مشروع قناطر نجع حمادى الجديدة

مشكلة انهيار ميول قناة التحويل

Site visit of dredging works
for
New Naga Hammadi Barrage and Hydropower Project

**Study of Slope Failures During Excavation  
of the Diversion Canal: A Case Study**

**fig. 1: CSDs El Marwa (left) and El Safa (right) dredging the diversion canal**

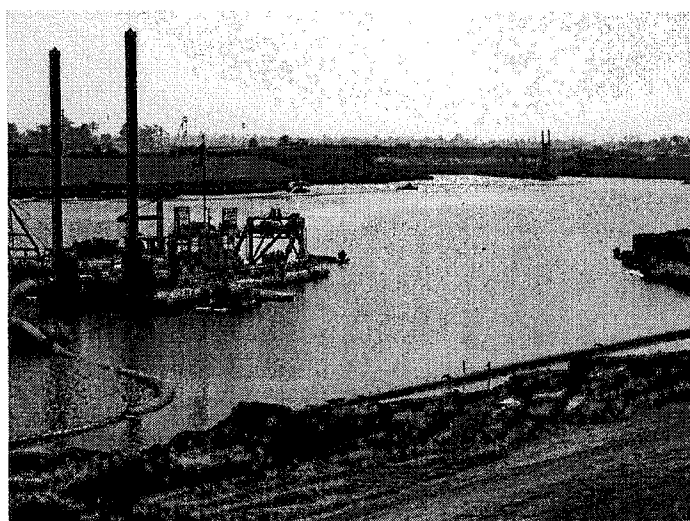
The CSDs seem to be in acceptable condition. The auxiliary floating equipment, too, seems to be in reasonable condition. Additional connectable floating pontoons have been mobilised to the site on Jan 23rd, 2003. Apparently they are old. The hull is covered by molluscs. NHBDC is advised to collect the proof of stability from the contractor under aspect of safety reasons.

**Remarks:** The CSD's design is old fashioned and due to the spud system used (s. fig. 1: spud stepping instead of advancing CSD via spud carriage with both spuds in CSD's C/L) they are less suitable, for slope dredging may be even unsuitable considering prevailing work conditions (for example regarding cut design, suction pipe mouth, pump force) .

**fig. 2: method and result of slope trial dredging**  
(demonstrating the volumes for final dredging of slope prior to embankment protection works)

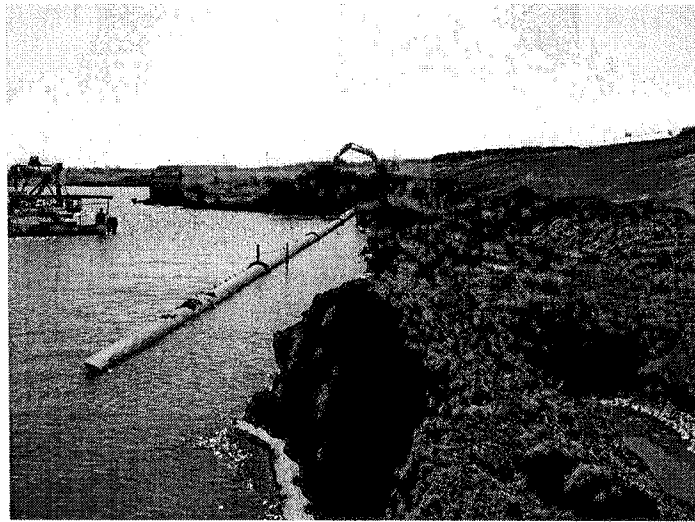
**Remarks:** The contractor has a wrong understanding of final levels to be dredged (s. annex 11, step 2 of his method statement, dated November 14th, 2002). This sketch clearly indicates contractor's intention not to dredge the designed depths. Some profiles from interim surveys of the works so far executed confirm this impression.

The contractor should be aware of the fact that by performing his revised slope dredging the final slope line would be located beyond the design line in direction to the canal's C/L.

Dredging the required slope includes overdredging. This overdredging, however, would create a slope failure of the embankment so far constructed, as the already finished area above elevation 59 will be undercut.

Once the slope is dredged in accordance with the method under trial right now, there remains still quite a volume to be dredged during a final dredging (due to the fact that the contractor works only the elevation 57 line). The contractor shall explain also the method and sequence of final dredging including the detailed stepping forward procedure.

In VP's opinion the contractor should minimize the specific volumes of the cut to be dredged. The contractor shall consider the consequence on productivity within his revised method statement.

In his working method the contractor has not identified consequences on the tolerance situation considering the dredge method of the CSDs (stepping). The contractor shall describe this situation in his revised method statement.

**Conclusion:** The contractor shall revise his method statement especially regarding slope dredging, explain and demonstrate the different steps in detail and shall comment the consequences regarding the volumes to be dredged as well as impacts on time schedule and shall inform NHBDC without any further delay.

**fig. 3: irregular reclamation with submerged discharge pipe outlet**  
**Positioning and work control**

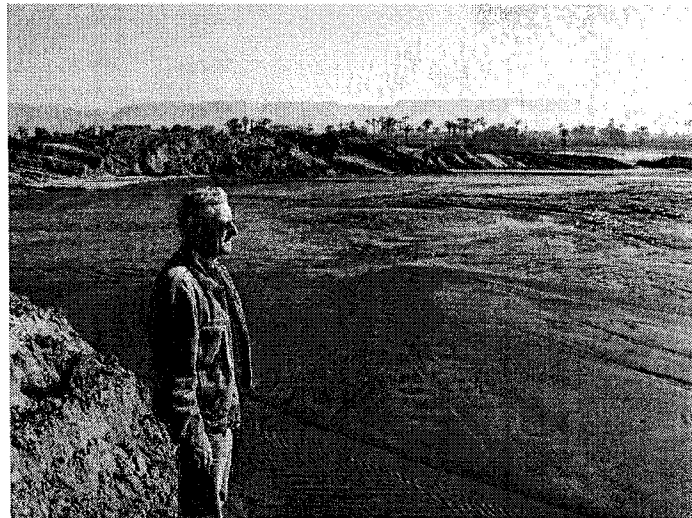
During the site visit of the reclamation area on January 23rd, 2003, 1 discharge pipe outlet was operating, however, the pipe was under water and the CSD was pumping against a sand wall under water (acting like a mineral fountain). The contractor explained that they could not suffer larger geodetic height unless reducing the pump capacity. This argument was refused by VP as not significant. Furthermore during discussions on Jan 23rd, 2003, it was revealed that the pump's impeller used was of 3 blade type. With 4 or 5 blades higher pressure easily could be reached. Arab Contractors have been advised to investigate this matter in more detail.

**Remarks:** A rough estimate made on Jan 24th, 2003 jointly Arab Contractors result in a required pressure of  $< 4,5$  bar whereas  $> 4,8$  bar are available on CSD El Safa.

So far no area reclaimed or levelled up to designed elevation could be recognized.

The kind of operation of the reclamation area is rather peculiar and definitely not in coincidence with the state of the art of dredging and reclamation works. Consequently to the work method the time schedule might be affected.

**Conclusion:** The contractor shall organize the reclamation area in accordance with the state of the art and contract conditions.

**fig. 4: positioning of cutter at cut between elevation 59 and 57**  
(floating line marks border line at elevation 57, small beam indicates cutterhead position)

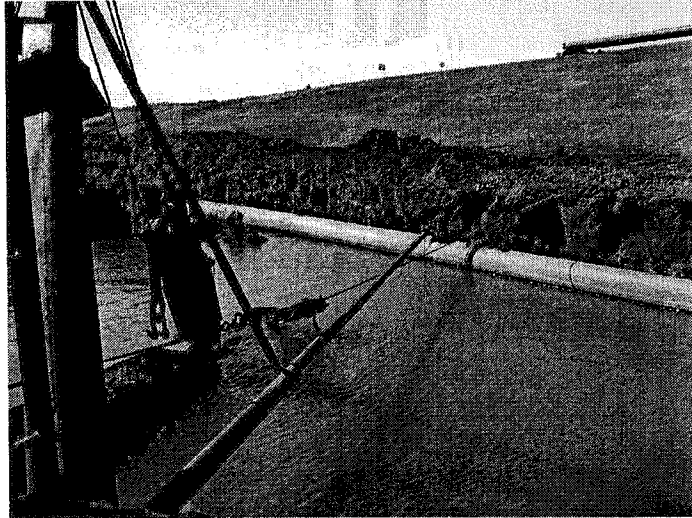
**Remarks:** For surveying a high frequency of 200 kHz is used. By this method already levels are indicated with material in suspension, whereas the solid ground could be in greater depth. VP recommends to NHBDC to make controls by comparison of depths sounded by echo sounder and lead as a first information. In case of differences a lower frequency ( for example 15 kHz or 30 kHz) should used for control works. By this effort re-dredging eventually could be avoided or at least reduced.

The CSDs positioning system is antique and completely unsatisfying. VP recommended and explained to the contractor a modern method of dredge control, allowing on-line control of the works on board as well as in office. Under prevailing conditions NHBDC in VP's opinion definitely needs a even on-line documentation of the dredging works under execution. Otherwise a prove of quality is not possible.

**Conclusion:** More control work is necessary when dredging the slope area. The contractor immediately should indicate his improved positioning and work control system to NHBDC.

**fig 6: soil to dredged (at slope failure #2)**

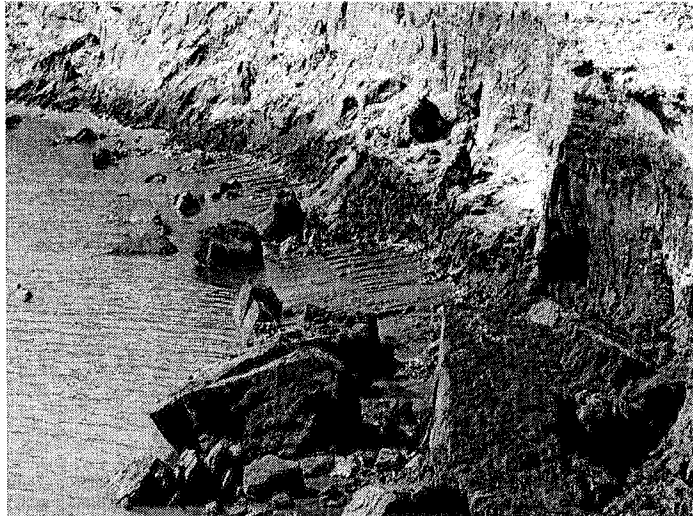
During initial slope dredging two slope failures were experienced. NHBDC by studies have proven, that the slopes in consideration of the relevant geo-technical parameters are stable.

NHBDC's calculations result in safety factors of  $h=1,41$  til  $h= 1,81$ , depending on the load combination assumed (s. Tender design report Vol.1 of September 2000). The safety factor of slope stability of  $h = 1,4$ , to be applied for normal load cases must be exceeded, what happened in all load combination cases analysed.

The slope in VP's opinion and experience in principle can be dredged with an inclination  $1:3 = H:L$  in case an adapted dredge programme is executed. A detailed soil investigation is considered necessary to get more information on the layer's location and variation. Once the final work method is elaborated, it might be revealed that the contractor does not stick to the requirements during execution. NHBDC must be able to control contractor's work.

Figure 1: Typical cross section in the diversion canal slope

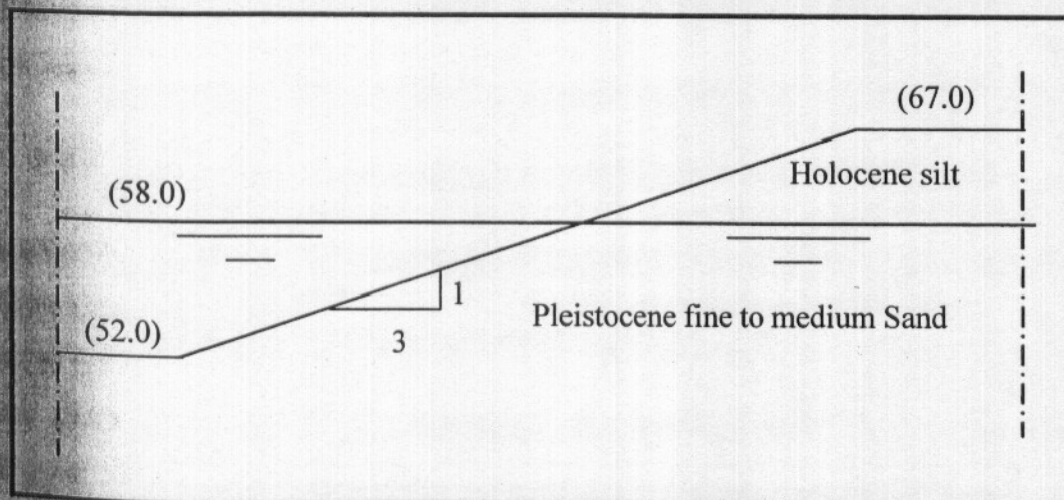
General experiences as well as simple calculations suggest that a 3H: 1V slope in loose to medium sands is a safe slope with adequate margin of safety under hydrostatic conditions. Assuming no lateral seepage through the investigated slope, two scenarios were found possible, in principal, to cause the reported failures. The first is the undercutting in the bottom sandy part of the slope, presumably due to over-dredging. The second is the loss of soil strength due to the effect of the suction pressure generated by the dredgers. Whereas the first scenario is less likely to happen, if proper operation and monitoring of dredging process is maintained, the second seems inevitable, as the hydraulic effects caused by the dredger's suction pressure cannot be avoided. Accordingly, our analysis has focused on the potential impact of suction on slope stability.

Suction dredging is, in essence, employed to remove soil particles, and draw them in the form of a sediment load into long disposal pipes to dump them some distance away from their original position. Therefore, the effect of a suction applied at the surface of a submerged sandy deposit may be viewed as a process of "accelerated piping failure" that has its peak effect at the surface, and extends into the submerged soil mass for some distance proportional, essentially, to the magnitude of suction applied. With this concept in mind, simplified calculations for a case of one-dimensional flow would readily show that a suction of 0.5 to 0.6 bar could result in the diminish of effective stresses, and consequently the loss of strength, for a soil column of about 7.0 m depth or more.
